Report No. TP00-21011

## 4M Change Notice: Low Profile Cutter Mechanism Series of Thermal Printer

Application/Notice of Change

## Summary of Change Contents

### Stress simulation before and after change»

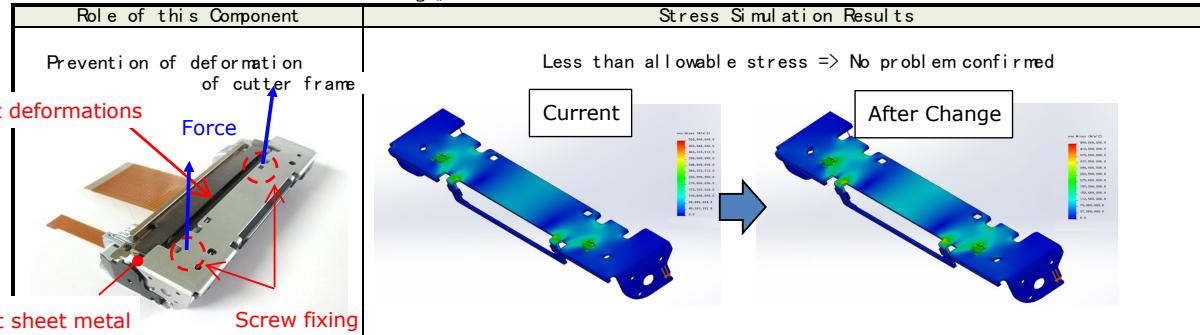
Content of Change	Reason	Current	After Change	Evaluation Results
1) Lock shaft shape	Consolidation of component structures			The structure that supports the shaft remains unchanged. Therefore, changing the shape will not affect the function.
2) Cutter unit sheet metal material (grade)	Consolidation of component structures	SUS304	SUS430	The material used after the change is a common one. Appearance is the same. Stress simulation was performed (no problem).

There is no change in the product function and outline before and after the change.  
Environmental data (chemSHERPA) will be submitted as necessary due to changes in printer components.

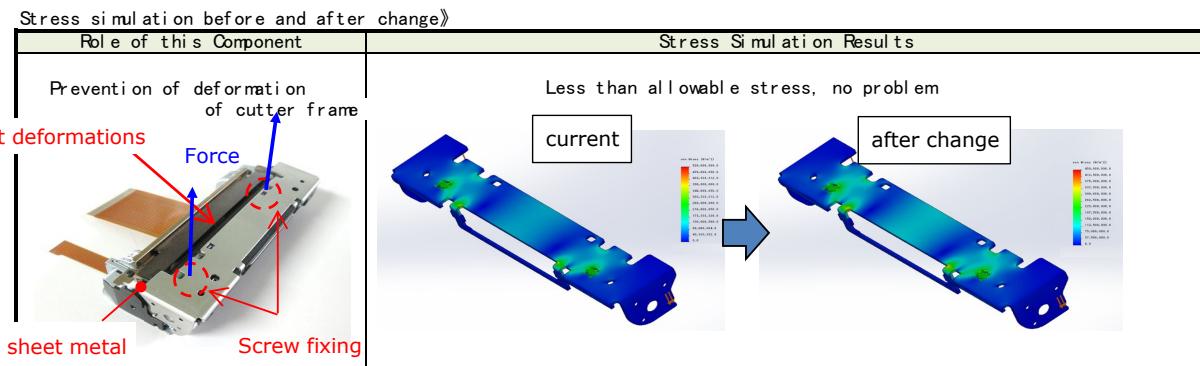
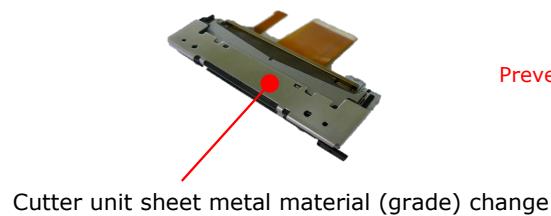
Schedule April / 2022~			
Subject Product : Thermal Printer <input type="checkbox"/>		Part number : FTP-627USL402-R			
Content of Change	Current		After Change		
	Cutter unit sheet metal material (grade) change .....				
Grade : SUS304		Grade : SUS430			
Reason for change <input type="checkbox"/>	Consolidation of component structures				
Related materials	Yes / No Attachment: Type-C Details)
